Reviewers' comments (Oct. 11th, 2017)

Summary: the article describes the layout, operation and performances of a Radial Time Projection Chamber with the electron amplification stage provided by three layers of GEM. The main novelty is the application of the electron multiplier for the amplification stage in a TPC on a semi-cylindrical shaped plane. The detector, originally built for the BoNuS experiment, is in fact formed by two semi-cylindrically shaped halves connected together, with the axis coincident with the beam line.

Figure 1: The number of active pads versus the measured momentum of the elastic ^4He tracks.

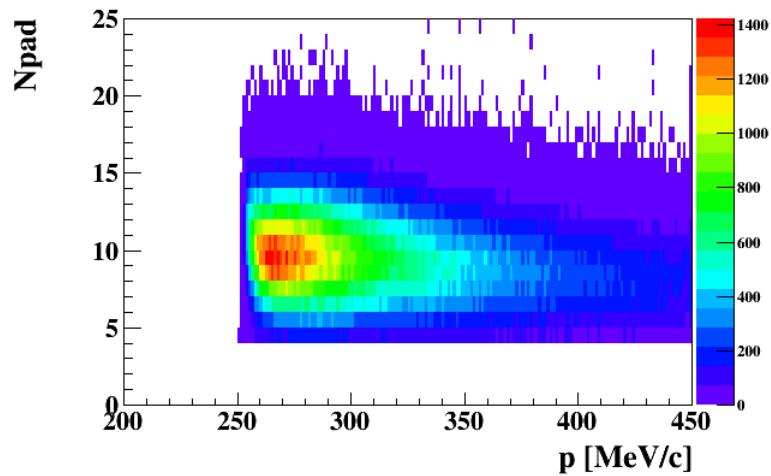
16. Figure 11: I don't understand it. How many tracks does the histo contain? If the single pad has 128 channels, how many channels does the single bin contain? Moreover, is the dE calculated on pad by pad basis? In that case, why don't you put just one point in the histo for each pad? What is the mean number of channels or pads fired by one track? Sorry for the list of questions, but I could not understand the figure.

- It is for only one track (written in the caption). - We don't understand your second question. A pad is a channel. Do you mean how many pads are fired for a single track? Figure ?? shows the number of active pads as a function of the momentum for the collected elastic ^4He tracks.

- dE is calculated from the ADCs of the individual pads that read out hits corresponding to the same track. One needed to know the individual step size very precisely to put dEdx from the individual pads, which is not available. - Last question is addressed by figure ??.

The mean value is around 10 pads.

Figure 2: the number of hits distribution for the collected elastic ^4He tracks from the 1.2 GeV dataset.

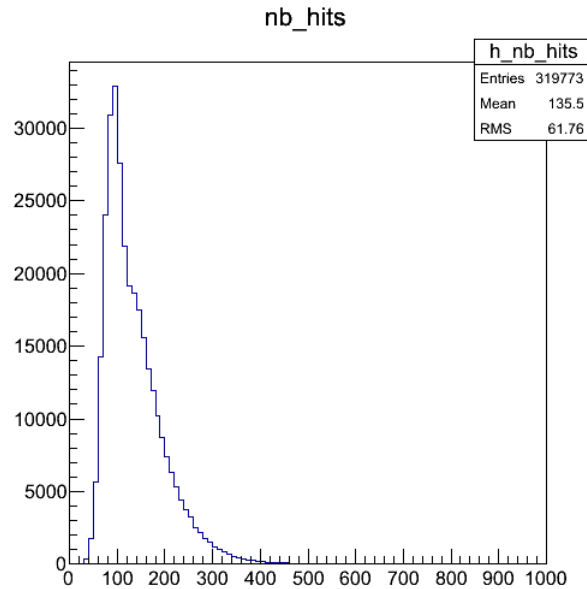
20. How was the "10 hits" cut chosen? What is the mean number of primary ionization in this gas mixture?

Figure 2 shows the number of hits distribution for the collected elastic ^4He tracks from the 1.2 GeV dataset. The mean number of hits is around 135 and the 10 hits cut at the reconstruction level is a loose cut to reduce the level of the spurious tracks.
